## Metro Outer Development Assessment Panel Agenda

**Meeting Date and Time:** Wednesday, 23 April 2025; 9:30am  
**Meeting Number:** MODAP/74  
**Meeting Venue:** 140 William Street, Perth

- 3.1 Part Lots 9550 and 9050 Alex Wood Drive, Forrestdale – Proposed Warehouse / Storage / Incidental Office – DAP/24/02752
- 3.2 Lot 501 (80) Gillam Drive, Kelmscott – Proposed Storage (Self Storage Facility) – DAP/25/02852

**Part B – Item 3.1 – ALEX WOOD DRIVE, PART LOTS 9550 AND  
9050, FORRESTDAL – PROPOSED WAREHOUSE /  
STORAGE / INCIDENTAL OFFICE**

DATE: APRIL 2025  
DRAWING: SITE PLAN GROUND FLOOR PLAN  
SCALE: 1:200 @ A1

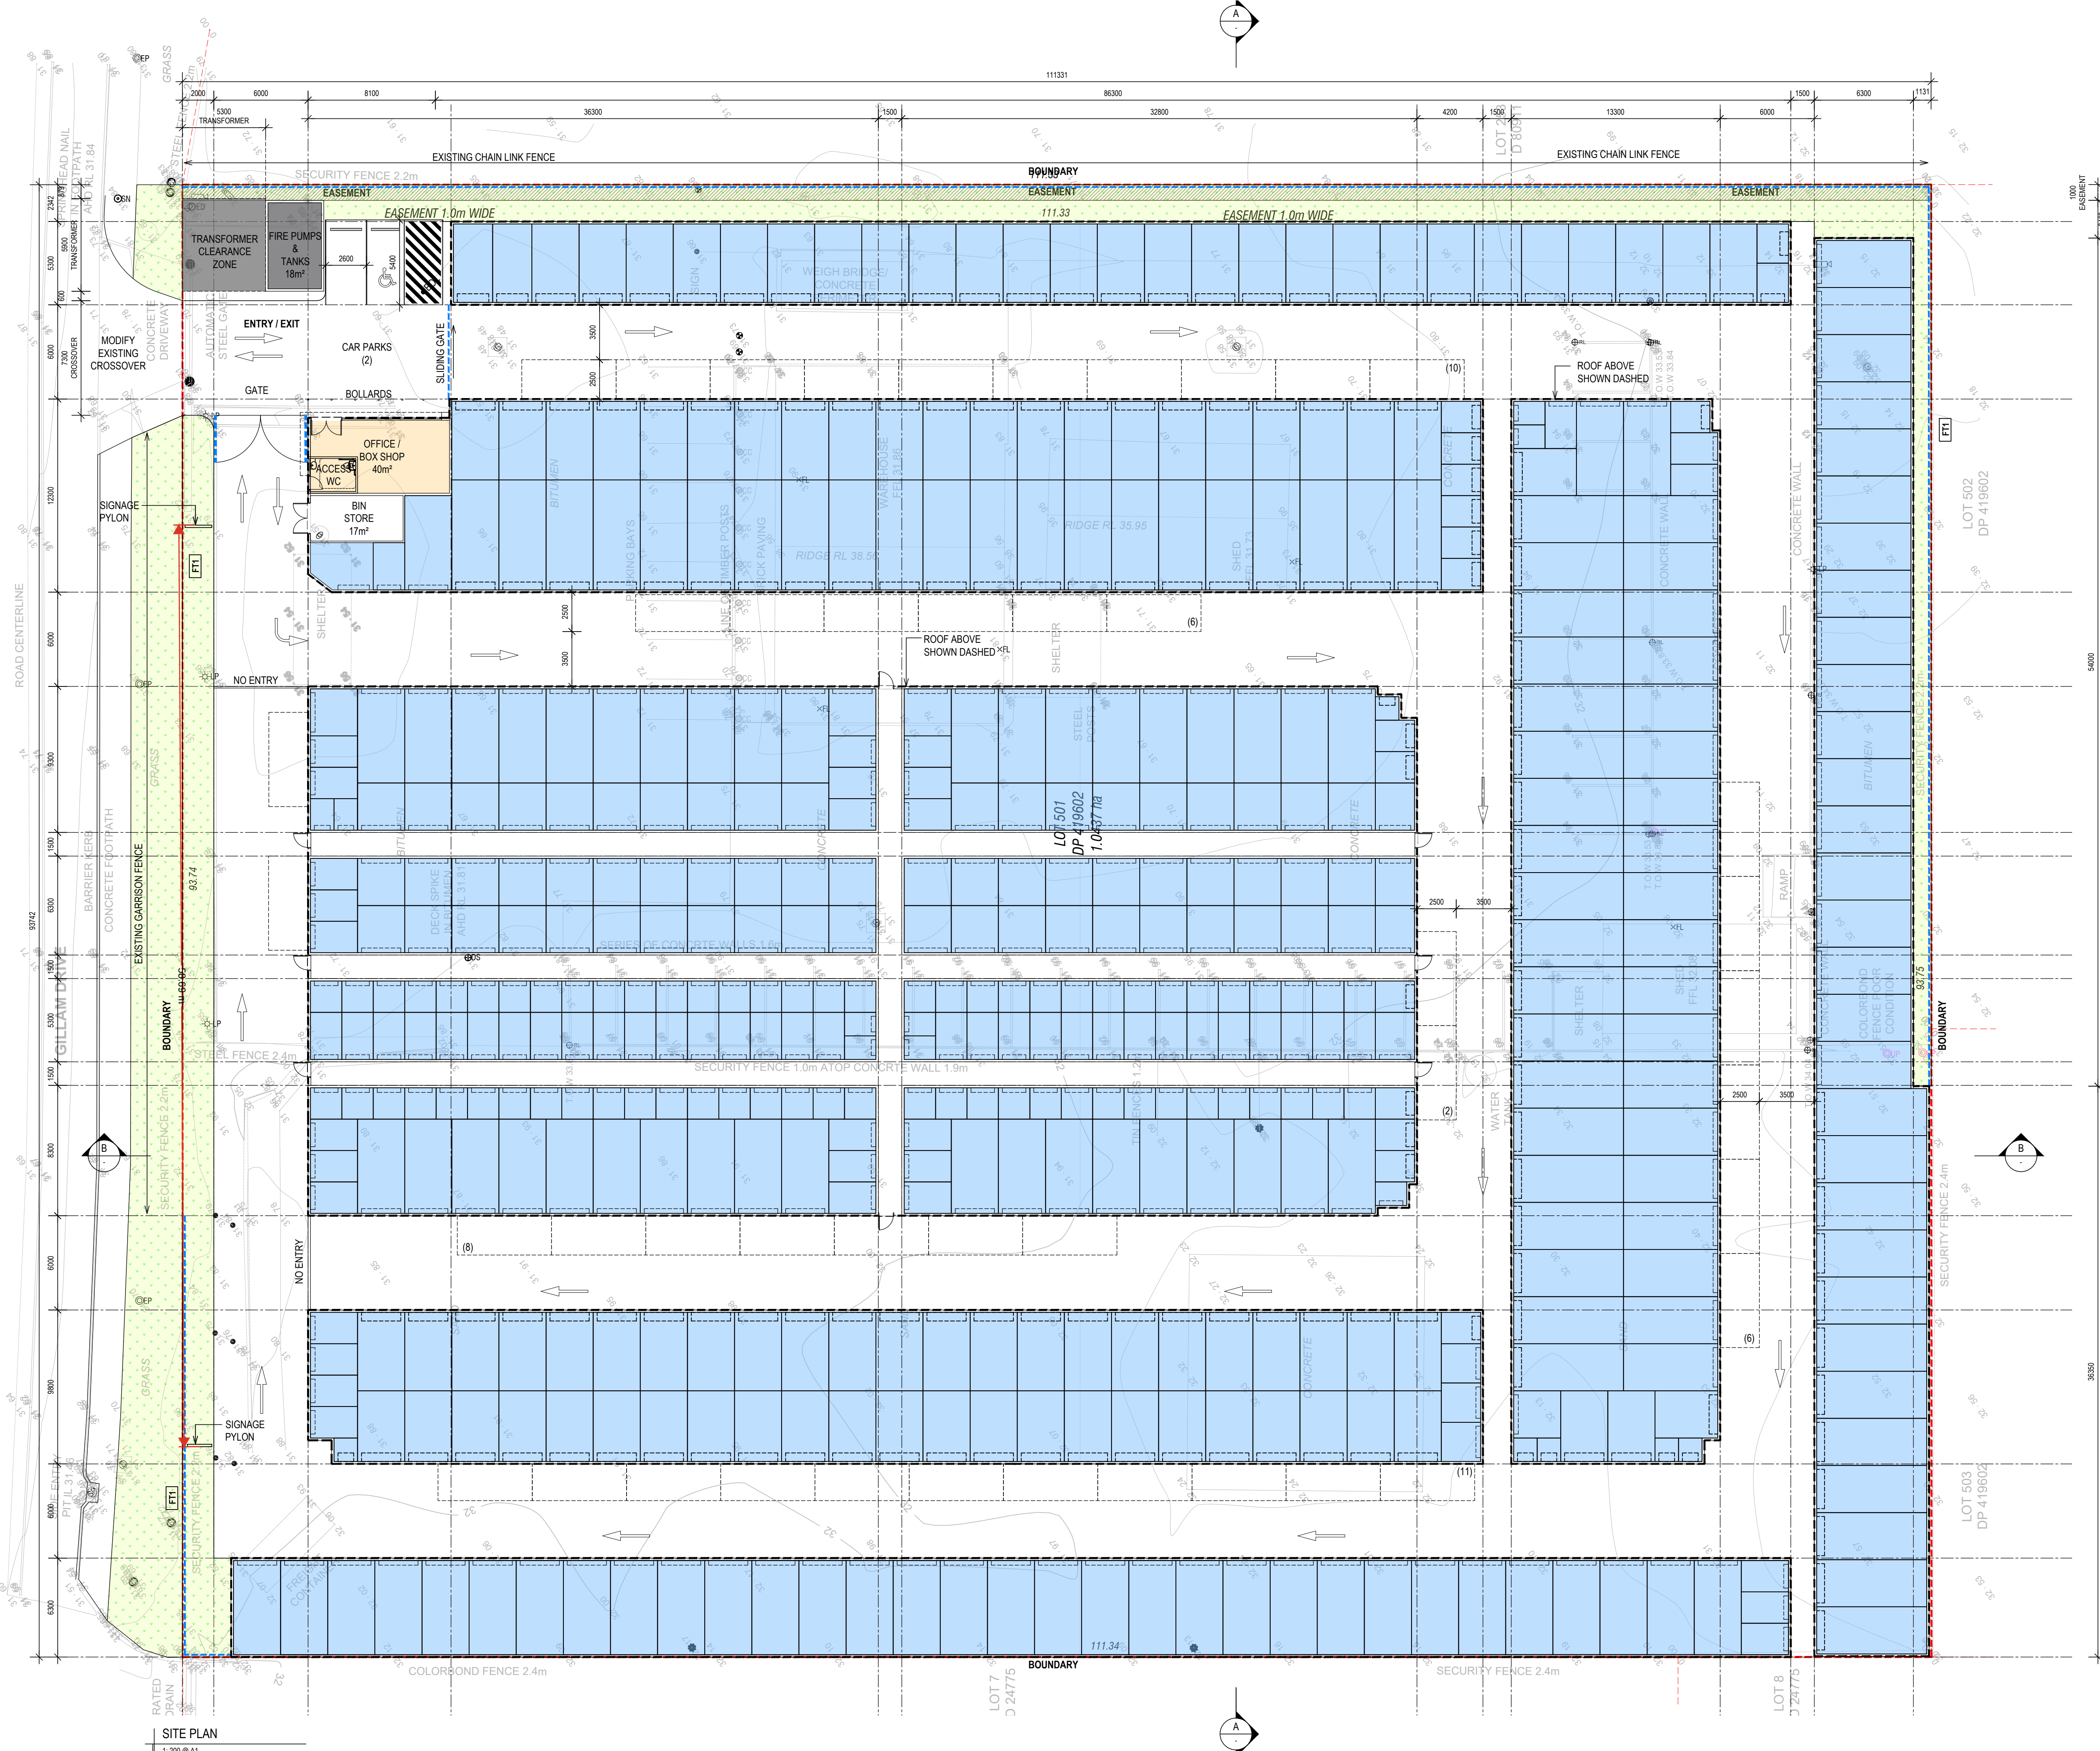
|                                              | <p>(e) the need for safe and convenient pedestrian access to and within the development site, including particularly access from the street and adjacent sites; and</p> <p>(f) the desirability of providing areas within or adjacent to the site for respite and relaxation by users of the development site.</p> <p>4D.4.3 Landscape planting is to be provided and maintained so as to minimise any adverse visual impact associated with the use and development of land, and is to include:</p> <p>(a) a minimum 2-metre-wide landscaping strip across all street boundaries;</p> <p>(b) a minimum 3-metre-wide landscape strip along all street boundaries within the 'General Industry' and 'Industrial Business' zone areas bound by Armadale Road, Ranford Road and Tonkin Highway.</p> <p>(c) provision of shade trees at a rate of one (1) tree per four (4) parking bays planted at intervals of no greater than 10 metres along any line of car parking bays. Where those bays are immediately adjacent to a building, the City may permit the required trees in another location on site.</p> | <p>Landscaping includes the required 2m wide landscaping strip along the front boundary plus the verge.</p> <p>Three (3) street trees proposed in the verge (nine (9) are required by PLN4.1 cl.4.7).</p> <p>Six (6) shade trees are proposed on site (eleven (11) are required).</p> |                                                                         |

**Vehicle Access** – the existing single crossover is to be modified to accommodate an internal circulation pattern designed to enable vehicles to leave in forward gear. Vehicle access is considered acceptable.

DATE: APRIL 2025  
DRAWING: SITE LANDSCAPE PLAN  
SCALE: 1:200 @ A1

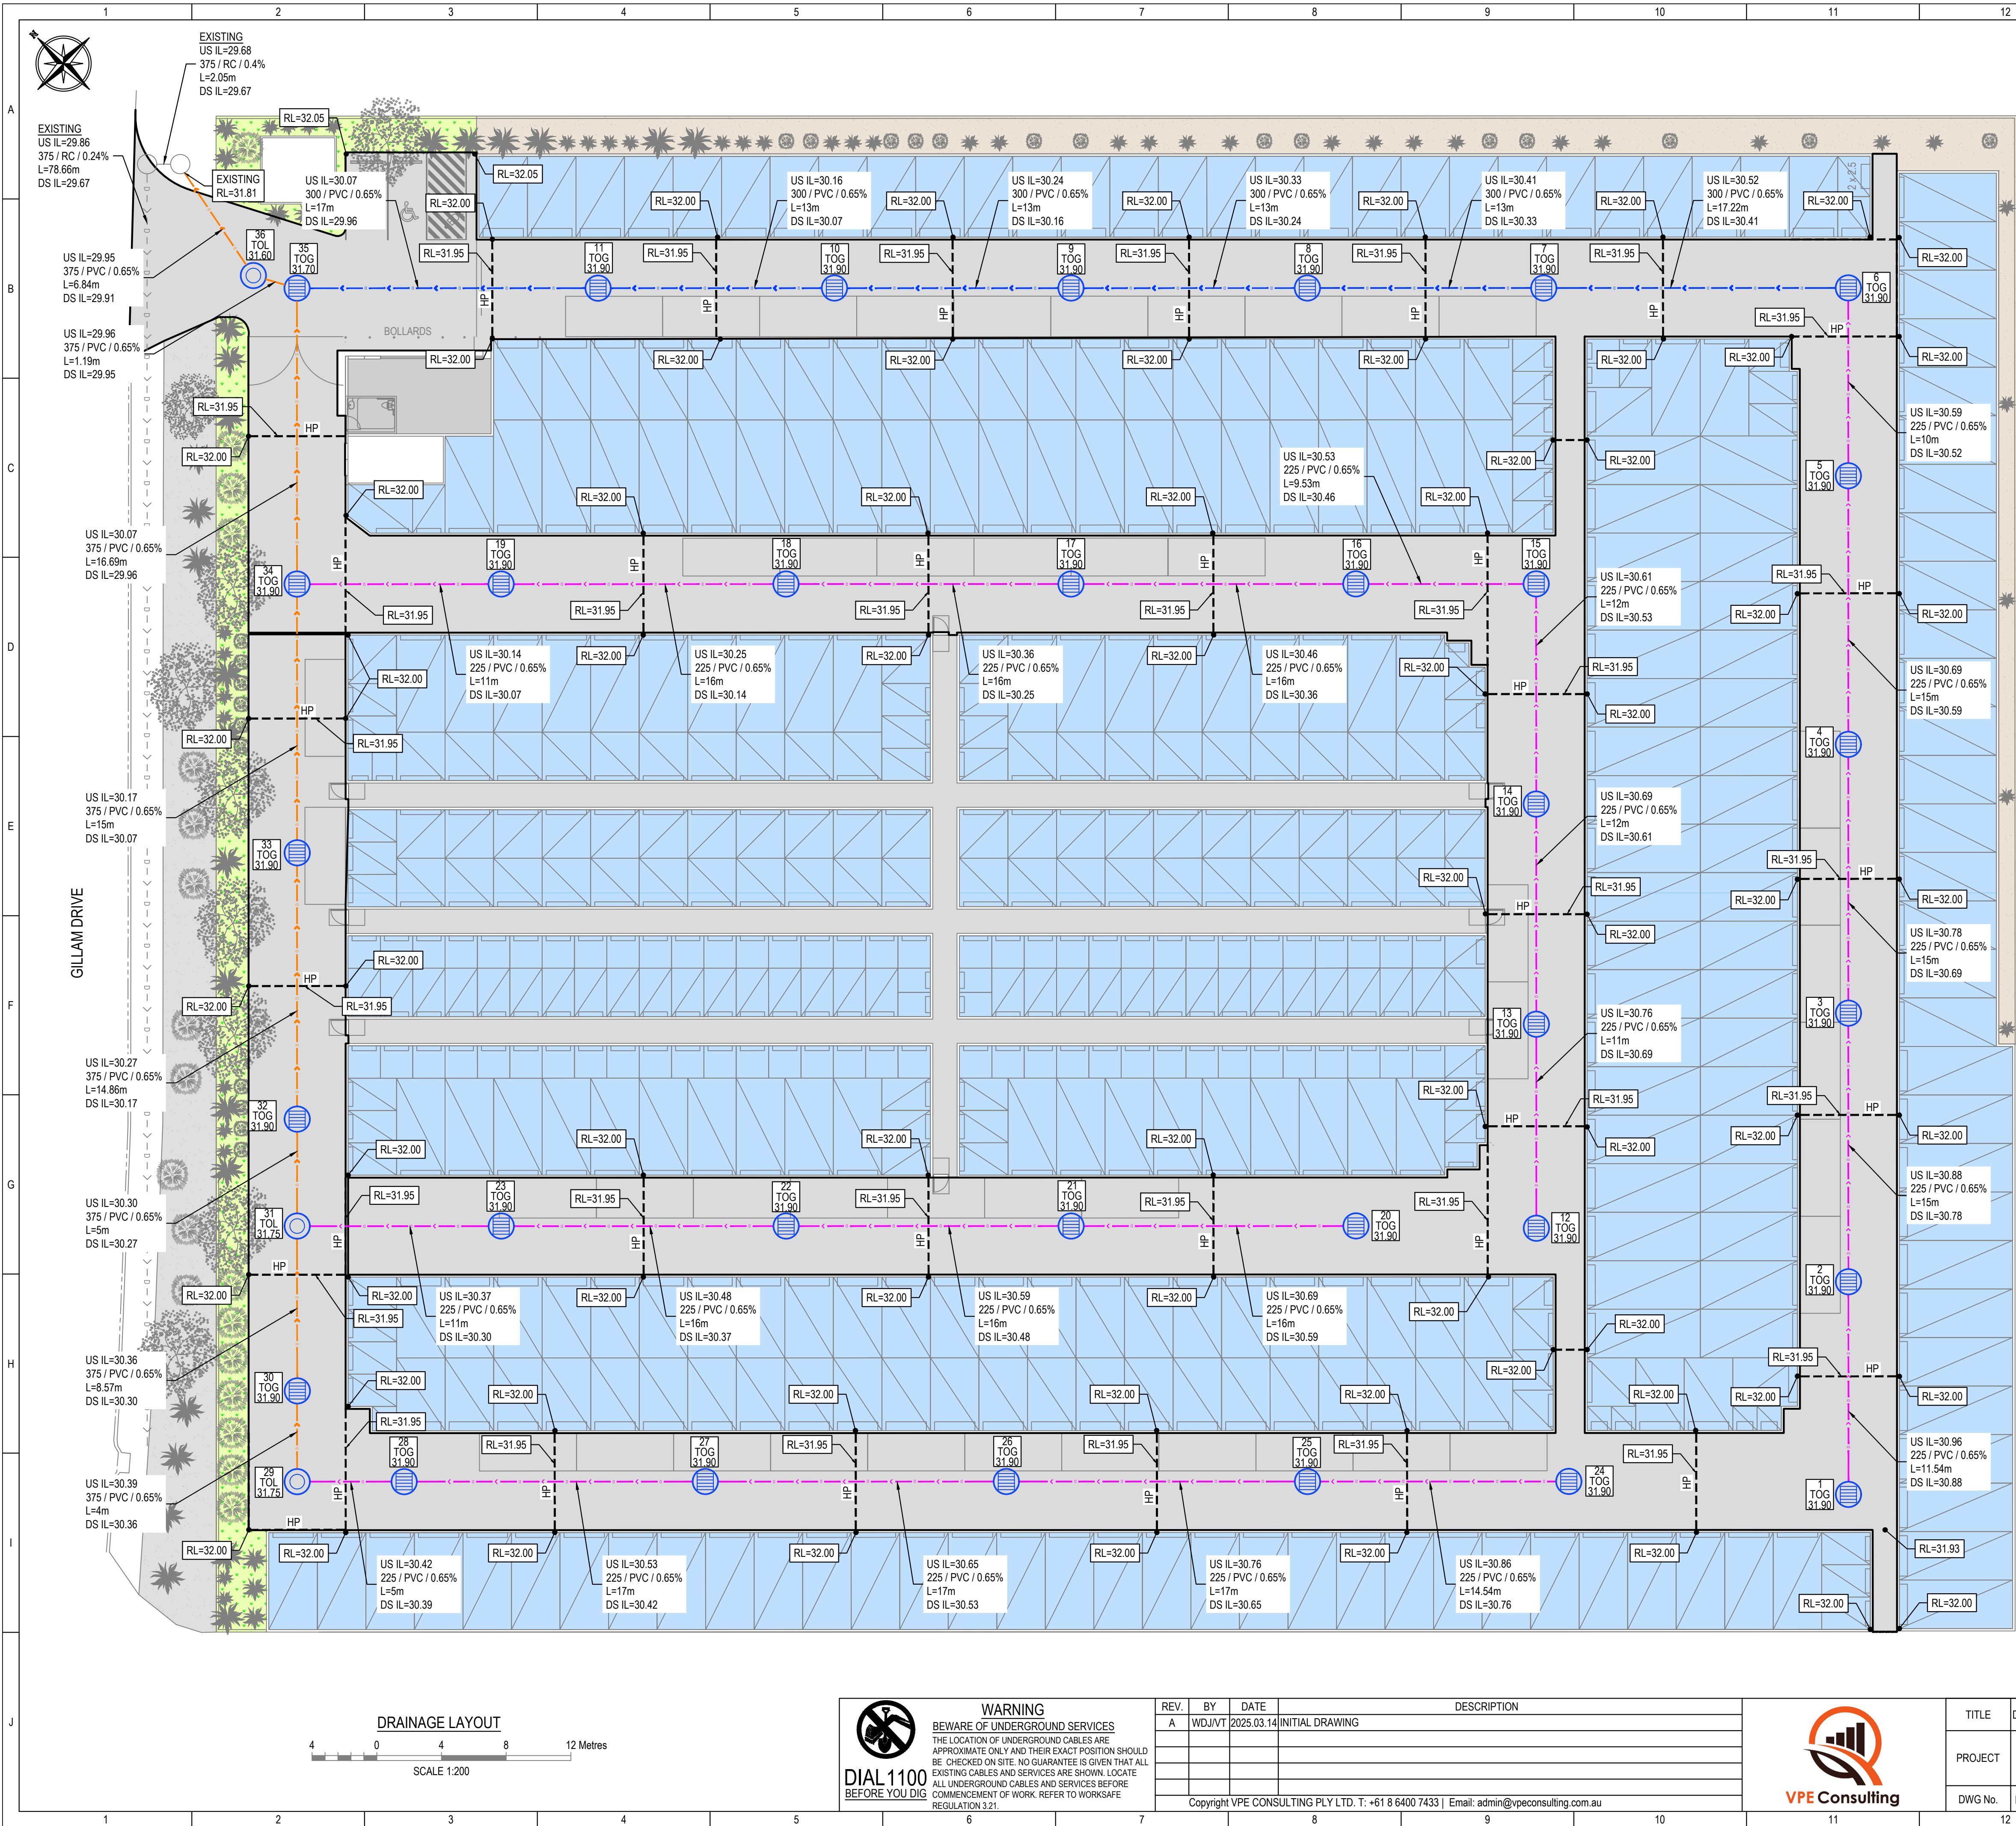
As noted earlier in this report (see City of Armadale Town Planning Scheme No.4 Planning Assessment), a concept Landscape Plan (Apr. 2025) has been submitted in support of the application. The Landscape Plan includes

In order to enhance the streetscape, local amenity and in support of the City's aims in relation to urban tree canopy, it is recommended that a revised Landscape Plan is required as a condition of approval to ensure that additional trees are provided in the verge and car parking area.

Landscaping – the submitted Landscape Plan (Dec 2024) was reviewed by the City and DRP and recommendations were made to the applicant for amendments. The applicant submitted a revised Landscape Plan (Apr 2025) which addresses many of the City's recommendations however the required minimum number of trees has not been provided. In order to enhance the streetscape, local amenity and in support of the City's aims in relation to urban tree canopy, it is recommended that a revised Landscape Plan is required as a condition of approval to ensure that additional trees are provided in the verge and car parking area.

3. With regard to the Condition requiring a Landscape Plan, please refer to the City of Armadale *Landscaping Guidelines – Industrial and Commercial*, *Landscaping Guidelines – Plants to Avoid*, the City's *Urban Forestry Strategy* and *Landscape Factsheet - Trees for Confined Spaces* to assist you to formulate a satisfactory landscaping proposal. Copies of these documents are available on the City of Armadale website at: <https://www.armadale.wa.gov.au/planning-information-sheets>. The City of Armadale has reviewed the Landscape Plan provided in the submission and advises that further amendment is required to increase the number of trees provided in the verge and carparking areas.
